Detailed changes and updates only

DA 2022/36

Mitchell Highway, Narromine, Lot 23 DP 1278134

Development applications changes and updates

RECEPTOR DISTANCES SHOWN BELOW

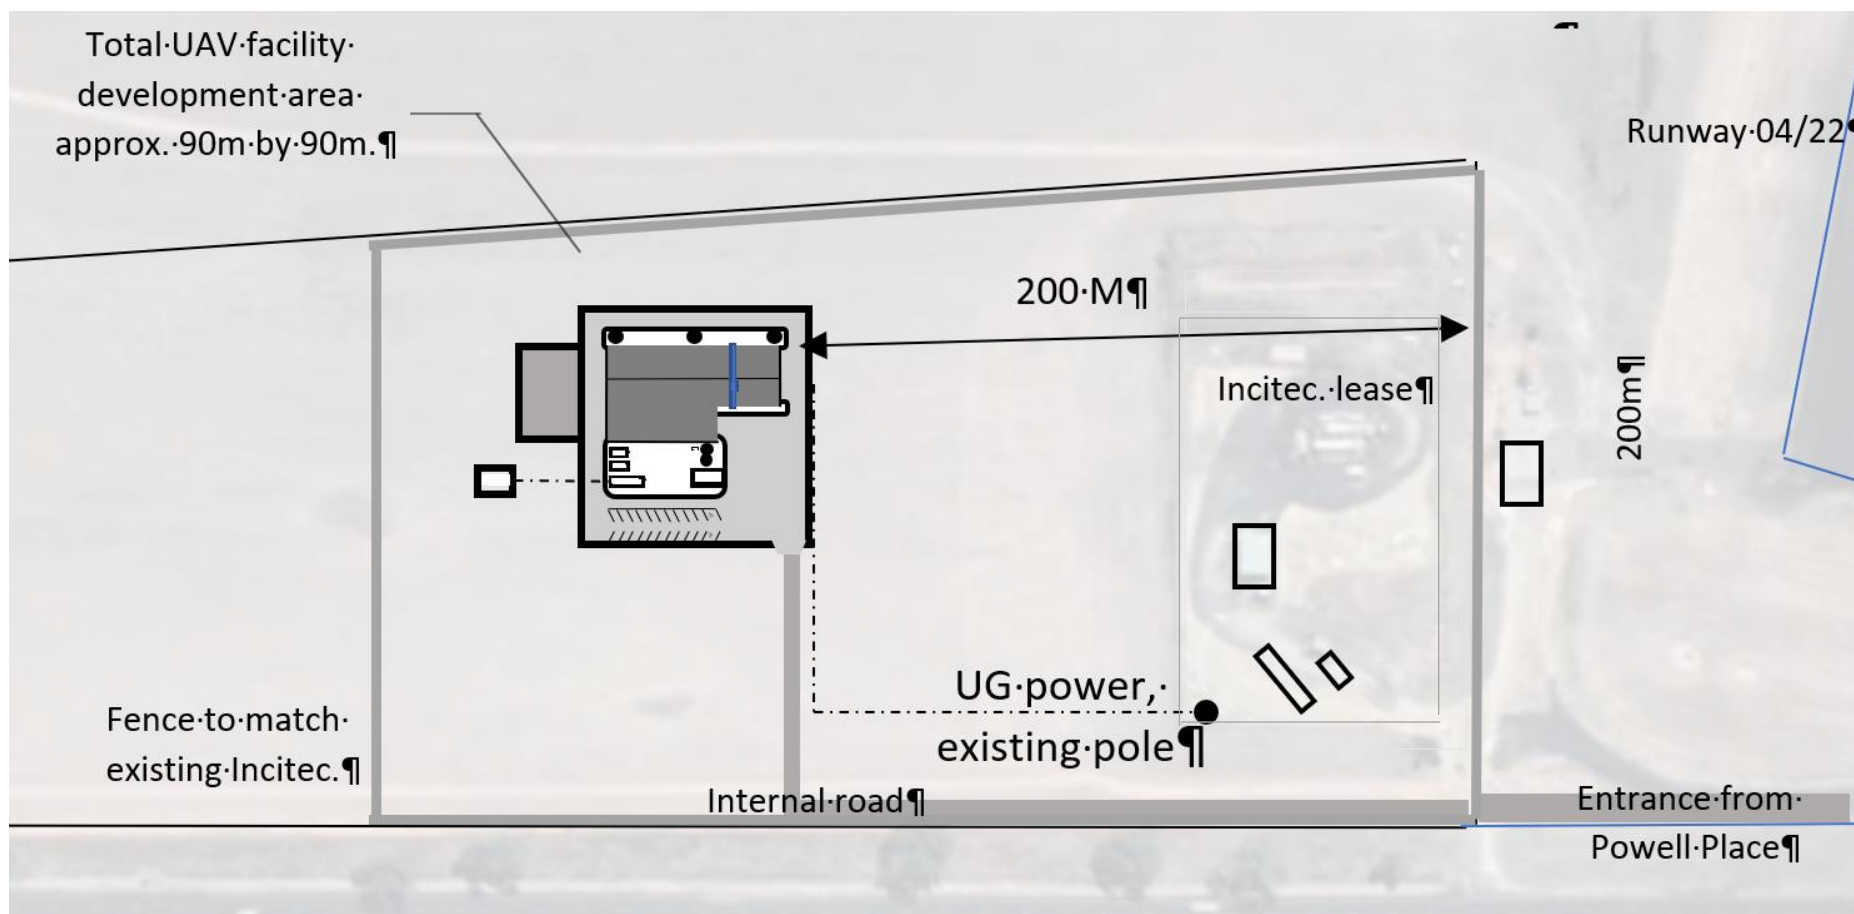
53	3.8 Noise and Air Quality 3.8.1 Noise 3.8.1.1 Construction noise 3.8.1.2 Operation noise	Receptors are located to the west and northwest of the development site. Noise levels are not expected to exceed noise general industrial levels.	yes	<p>Overall lower impact.</p> <p>The development will have less impact on the western receptor that indicated in SEE revision F.</p> <p>The development is closer to the new industrial estate.</p>
